SERVICE BULLETIN

N° 139-678

DATE: July 5, 2022

ATA 53 – MIDDLE PANEL RETROMOD INSTALLATION

Figure 12

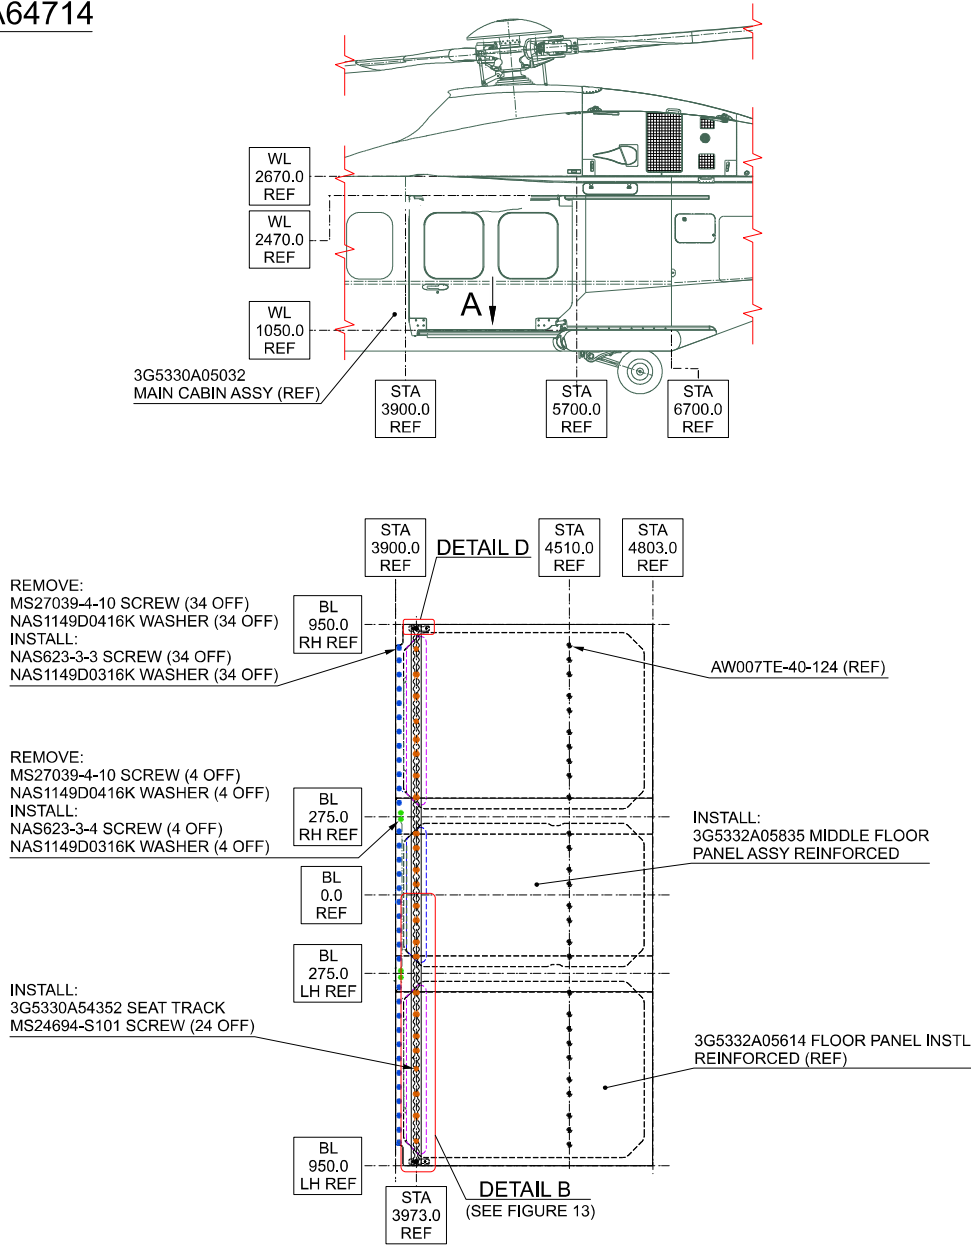
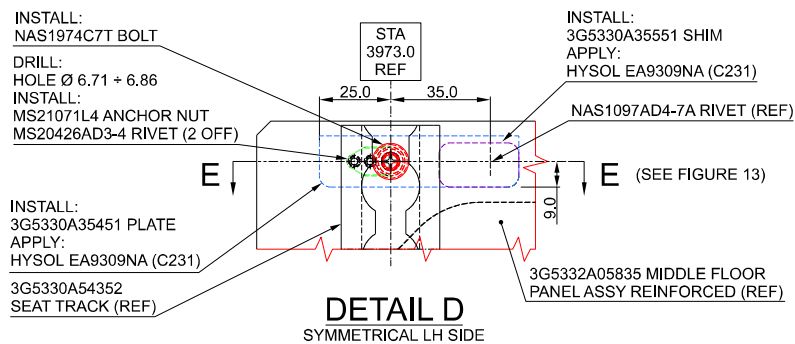
- 4.6 With reference to Figure 12 Detail D and Figure 13 Section E-E, temporary locate the shims P/N 3G5330A35551 and the plates P/N 3G5330A35451 on the middle floor panel assy reinforced P/N 3G5332A05835.

- 4.7 With reference to Figure 12 Detail D and Figure 13 Section E-E, drill n°2 rivet holes thru the shims P/N 3G5330A35551, the plates P/N 3G5330A35451 and the middle floor panel assy reinforced P/N 3G5332A05835 in accordance with dimensions shown.

- 4.8 With reference to Figure 12 Detail D and Figure 13 Section E-E, install n°2 shims P/N 3G5330A35551 and n°2 plates P/N 3G5330A35451 on the middle floor panel assy reinforced P/N 3G5332A05835 by means of n°2 rivets P/N NAS1097AD4-7A and adhesive Hysol EA9309NA (C231).

- 4.9 With reference to Figure 12 Detail D and Figure 13 Section E-E, drill n°2 holes $\varnothing 6.71 \div 6.86$ thru the shims P/N 3G5330A35551, the plates P/N 3G5330A35451 and the middle floor panel assy reinforced P/N 3G5332A05835 in accordance with dimensions shown.

- 4.10 With reference to Figure 12 Detail D and Figure 13 Section E-E, install n°2 anchor nuts P/N MS21071L4 on plates P/N 3G5330A35451 by means of n°4 rivets P/N MS20426AD3-4.

- 4.11 With reference to Figure 12 View A and Detail D, install the seat track P/N 3G5330A54352 on the doubler P/N 3G5332A19951 and doublers P/N 3G5332A19851 by means of n°24 screws P/N MS24694-S101 and n°2 bolts P/N NAS1974C7T.

- 4.12 With reference to Figure 12 View A, install the middle floor panel assy reinforced P/N 3G5332A05835 on the cabin structure by means of n°34 screws

Figure 13

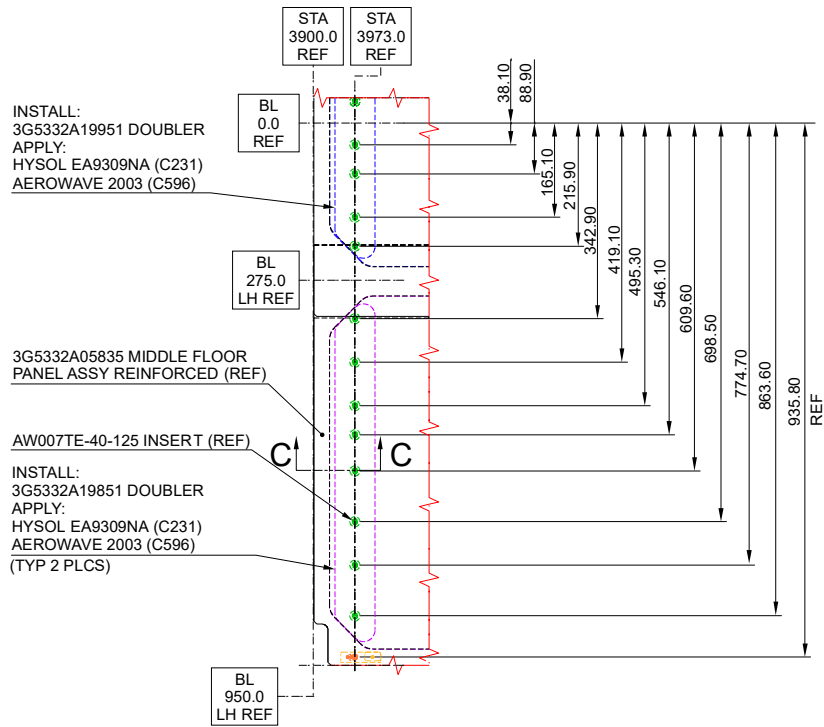
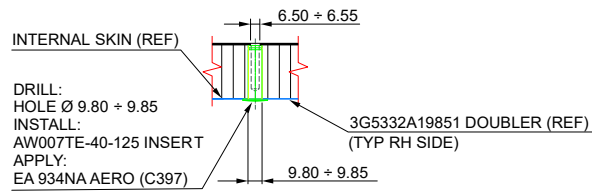
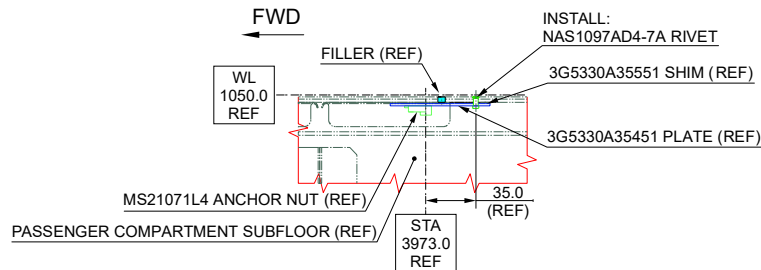
- 4.2 With reference to Figure 16, rework the reinforced central panel P/N 3G5332A05835 as follows:
 - 4.2.1 With reference to Figure 16 Detail A and Section B-B, drill n°28 holes Ø9.80÷9.95 thru the middle floor bonded panel assy P/N 3G5332A08933 in accordance with the dimensions shown.
 - 4.2.2 With reference to Figure 16 Section B-B, install n°28 inserts P/N AW007TE-40-124 on the middle floor bonded panel assy P/N 3G5332A08933 by means of adhesive EA 934NA AERO (C397). Apply a coat of grey paint to restore the treated surface.
- 4.3 With reference to Figure 13 Detail B, install n°1 doubler

- 4.4 With reference to Figure 13 Detail B and Section C-C, drill n°24 holes $\varnothing 9.80 \div 9.85$ thru the doubler P/N 3G5332A19951, the doublers P/N 3G5332A19851 and the middle floor panel assy reinforced P/N 3G5332A05835 in accordance with the dimensions shown. Countersink panel and structure.

- 4.5 With reference to Figure 13 Detail B and Section C-C, install n°24 inserts P/N AW007TE-40-125 on doubler P/N 3G5332A19951 and doublers P/N 3G5332A19851 by means of adhesive EA 934NA AERO (C397).

Figure 14

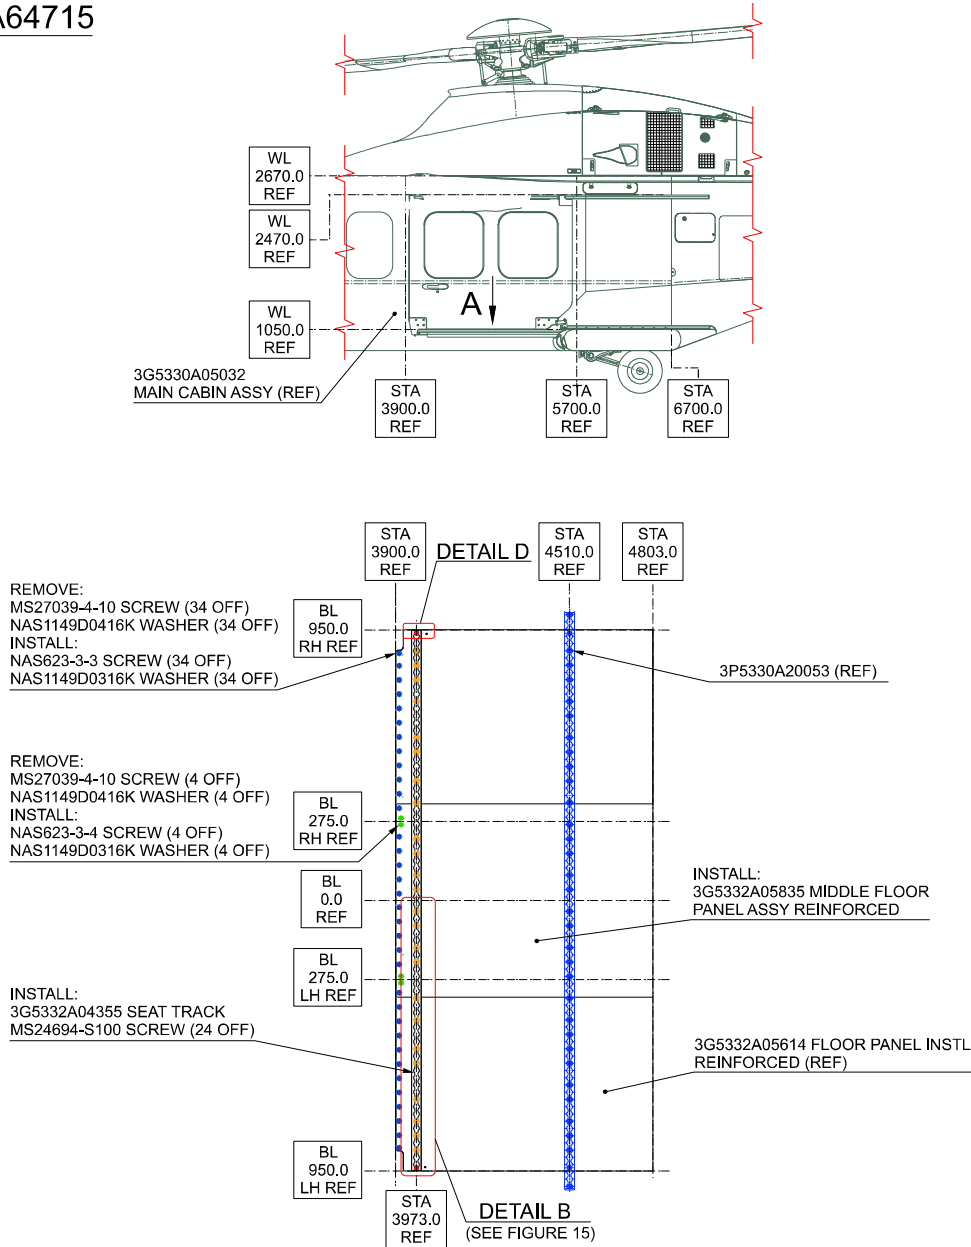
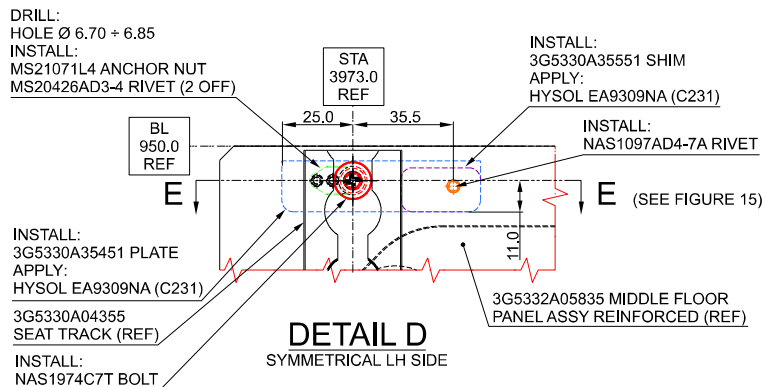
- 4.6 With reference to Figure 14 Detail D and Figure 15 Section E-E, temporary locate the shims P/N 3G5330A35551 and the plates P/N 3G5330A35451 on the middle floor panel assy reinforced P/N 3G5332A05835.

- 4.8 With reference to Figure 14 Detail D and Figure 15 Section E-E, install n°2 shims P/N 3G5330A35551 and the n°2 plates P/N 3G5330A35451 on the middle floor panel assy reinforced P/N 3G5332A05835 by means of n°2 rivets P/N NAS1097AD4-7A and adhesive Hysol EA9309NA (C231).

- 4.9 With reference to Figure 14 Detail D and Figure 15 Section E-E, drill n°2 holes $\varnothing 6.70 \div 6.85$ thru the shims P/N 3G5330A35551, the plates P/N 3G5330A35451 and the middle floor panel assy reinforced P/N 3G5332A05835 in accordance with dimensions shown.

- 4.10 With reference to Figure 14 Detail D and Figure 15 Section E-E, install n°2 anchor nuts P/N MS21071L4 on plates P/N 3G5330A35451 by means of n°4 rivets P/N MS20426AD3-4.

- 4.11 With reference to Figure 14 View A and Detail D, install the seat track P/N 3G5332A04355 by means of n°24 screws P/N MS24694-S100 and n°2 bolts P/N NAS1974C7T.

- 4.12 With reference to Figure 14 View A, install the middle floor panel assy reinforced P/N 3G5332A05835 on the cabin structure by means of n°34 screws P/N NAS623-3-3, n°4 screws P/N NAS623-3-4 and n°38 washers P/N NAS1149D0316K.

Figure 15

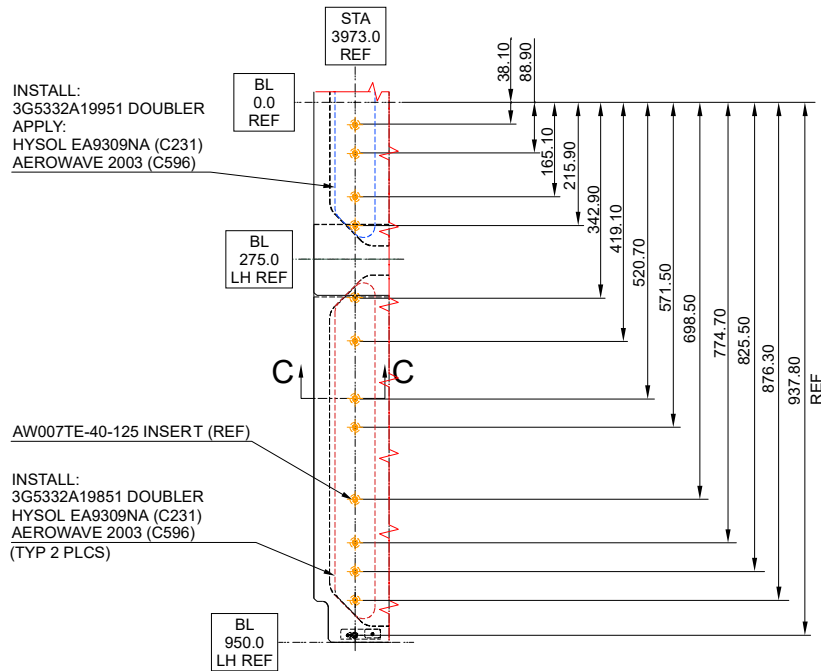
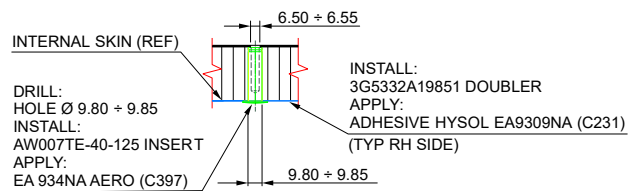
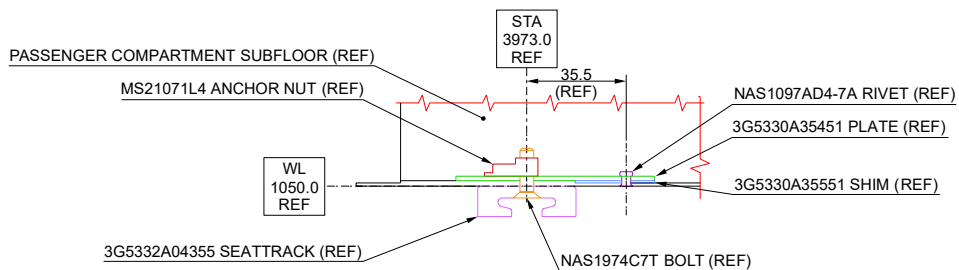
- 4.2 With reference to Figure 16, rework the reinforced central panel P/N 3G5332A05835 as follows:
 - 4.2.1 With reference to Figure 16 Detail A and Section B-B, drill n°28 holes Ø9.80÷9.95 thru the middle floor bonded panel assy P/N 3G5332A08933 in accordance with the dimensions shown.
 - 4.2.2 With reference to Figure 16 Section B-B, install n°28 inserts P/N AW007TE-40-124 on the middle floor bonded panel assy P/N 3G5332A08933 by means of adhesive EA 934NA AERO (C397). Apply a coat of grey paint to restore the treated surface.
- 4.3 With reference to Figure 15 Detail B, install n°1 doubler

- 4.4 With reference to Figure 15 Detail B and Section C-C, drill n°24 holes $\varnothing 9.80 \div 9.85$ thru the doubler P/N 3G5332A19951, the doublers P/N 3G5332A19851 and the middle floor panel assy reinforced P/N 3G5332A05835 in accordance with the dimensions shown. Countersink panel and structure.

- 4.5 With reference to Figure 15 Detail B and Section C-C, install n°24 inserts P/N AW007TE-40-125 on doubler P/N 3G5332A19951 and doublers P/N 3G5332A19851 by means of adhesive EA 934NA AERO (C397).

- 4.7 With reference to Figure 15 Detail D and Section E-E, drill n°2 rivet holes thru the shims P/N 3G5330A35551, the plates P/N 3G5330A35451 and the middle floor panel assy reinforced P/N 3G5332A05835 in accordance with dimensions shown.

Figure 17

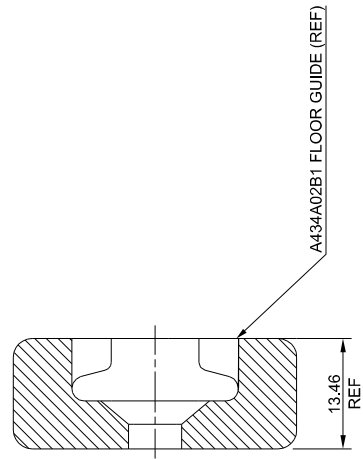
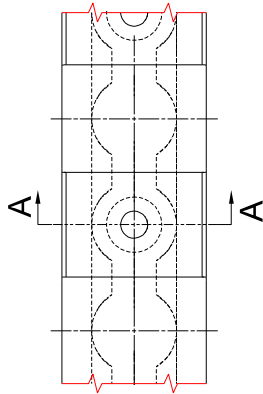
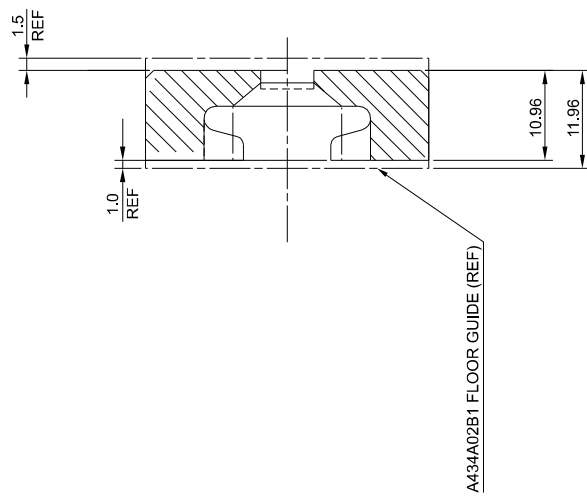
2. With reference to Figure 17 Section A-A and Section B-B, check the seat track height to find out which seat track is installed on the middle floor panel P/N 3G5332A05834 or P/N 3G5332A05832:
 - 2.1 if the seat track P/N 3G5330A54351 is installed on the helicopter order the rail STA3973 installation P/N 3G5330A64714;
 - 2.2 if the seat track P/N 3G5332A04351 is installed on the helicopter order the rail STA3973 installation P/N 3G5330A64715.
 - 2.3 Record the P/N of the seat track installed and the relevant information in the report in ANNEX A.
